WOLF CREEK

NUCLEAR OPERATING CORPORATION

Subject: Docket No. 50-482: Response to Request for Additional Information – Extensions of AC Electrical Power Distribution Completion Times

RESPONSES TO REQUEST FOR ADDITIONAL INFORMATION

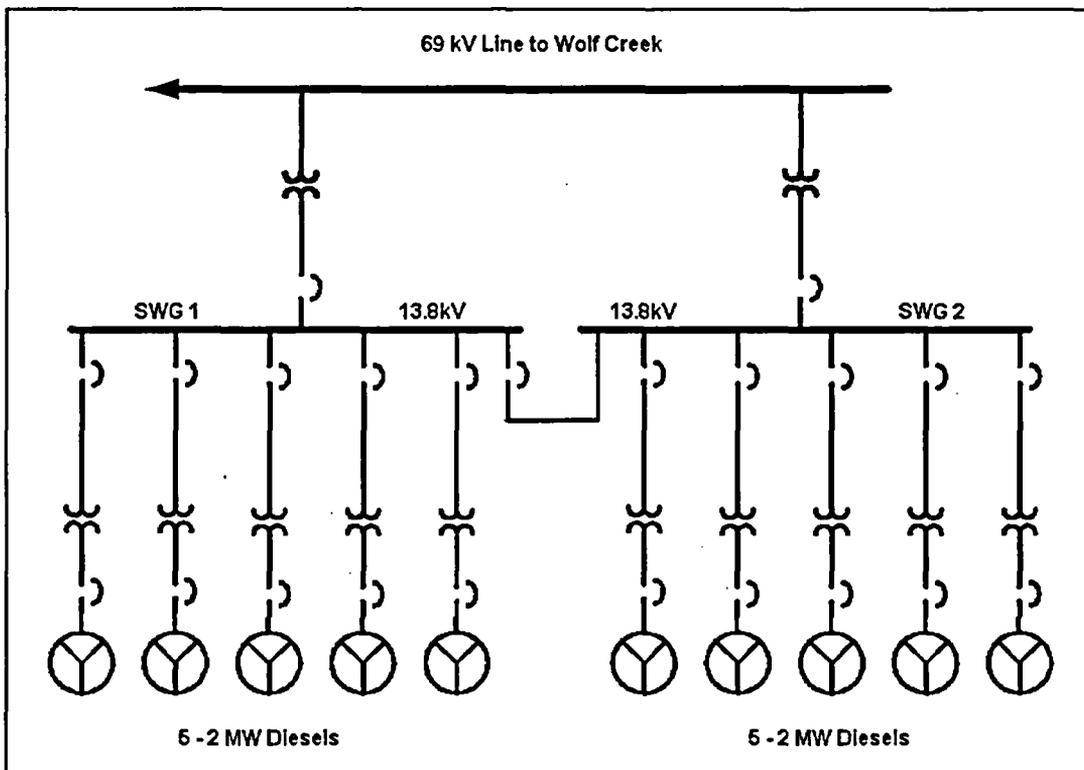
- b. Typical PSA model fault tree basic events for the DGs include fail-to-start, fail-to-run, and test-and-maintenance. Each of these terms can account for the protection equipment listed, and a subsequent DG model failure. Other 'signal-based' logic failures could also cause the EDG to not function. Since the type of testing and frequency of the testing is not being changed from what is currently performed, there should be no increase in risk if the Completion Time is increased.
24. The licensee's response to RAI 7 provided in attachment 2 to its application states: "...There are no commonalities between the WCGS DGs and the Sharp Station..." When a Wolf Creek DG is connected to the offsite system for post maintenance testing, describe why there are no commonalities between the DG and the Sharp Station.

The 69 kV line can be aligned to be common between the WCGS DGs and the Sharpe Station (see the simplified one-line diagram on page 4 of Attachment I to WO 03-0057). But typically this is not the case. The Sharpe Station gensets are peaking units and are not generally connected to the grid (69 kV line). Use of the Sharpe Station gensets would be during periods of challenged high load grid conditions. WCNOC response to RAI 7 in Attachment II to WO 03-0057 indicated that extended DG maintenance period are selected during historical time frames of low severe weather frequency and favorable weather periods tend to avoid periods of high grid demand. Prior to connecting to the offsite system for post maintenance testing WCNOC will contact the grid operator to review grid stability issues. Additionally the WCNOC DGs are of

the Fairbanks Morris –Colt Pielstick PCV2.5 design and the Sharpe Station gensets are Caterpillar 3516B design. There are no commonalities in the two designs.
